**BEFORE
THE OHIO POWER SITING BOARD**

Case No. 21-868-EL-BGN

**SCIOTO FARMS SOLAR PROJECT, LLC'S RESPONSE TO
STAFF'S FIRST DATA REQUEST**

Figure No. 2-A

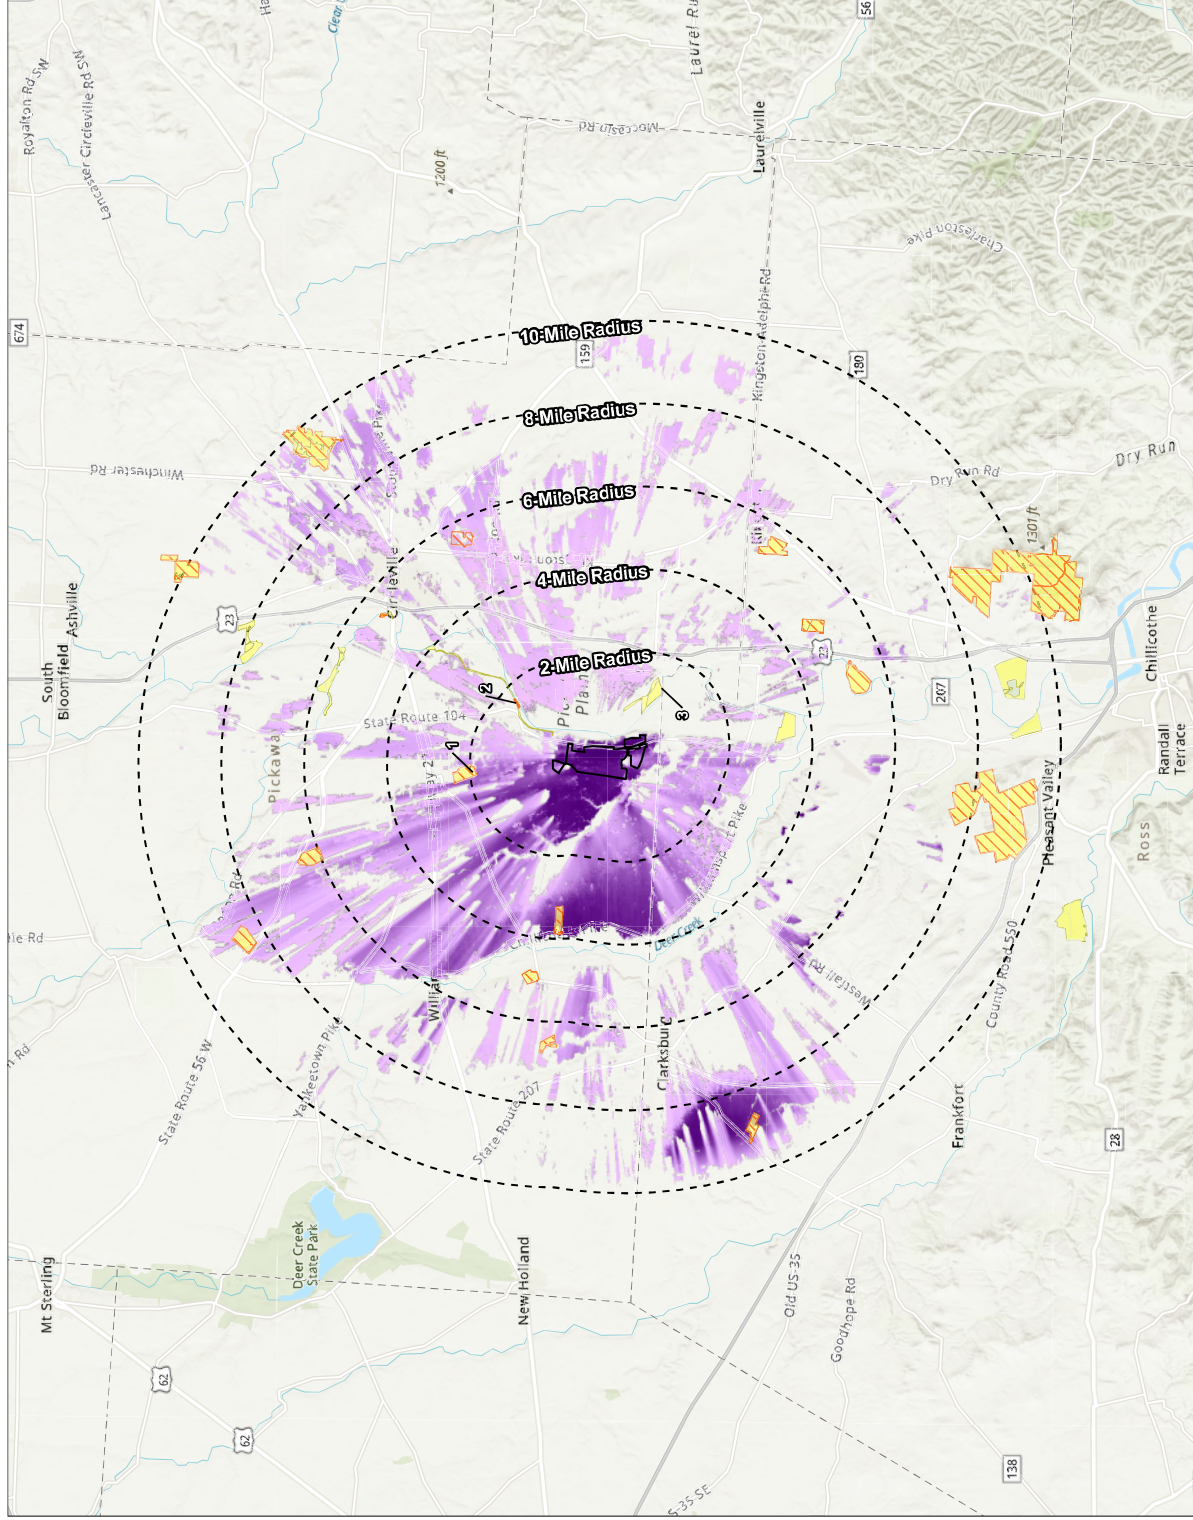
- 9) In accordance with 4906-4-08(D)(3), “describe the identified recreation and scenic areas within ten miles of the project area in terms of their proximity to population centers, uniqueness, topography, vegetation, hydrology, and wildlife. [Include] an evaluation of the impact of the proposed facility on identified recreational and scenic areas within ten miles of the project area and describe plans to mitigate any adverse impact.” Provide further detail on each recreational resource, as well specific detail as to whether the project would be visible from each recreational resource.

RESPONSE: Table 8-10 Recreational Areas Within a 10-mile Radius of the Project Area has been updated to provide additional detail on each recreational area identified within 10 miles. In addition, the Applicant has rerun the viewshed assessment (Visual Resources Technical Report (Exhibit U)) to include the existing vegetation on the landscape to provide a realistic determination regarding the potential visibility of each recreation area. A uniform deciduous vegetation height of 40 feet was used with the model. Consistent with the Visual Resources Technical Report included in the Application (Exhibit U), it was assumed that any resource located at a distance greater than 2 miles from the Project is not actually visible to the human eye. The results of the updated viewshed are provided in the attached Figure 2-A - Visibility of Recreation and Scenic Areas

Within 10 Miles of Project Area and Table 8-10 (revised).
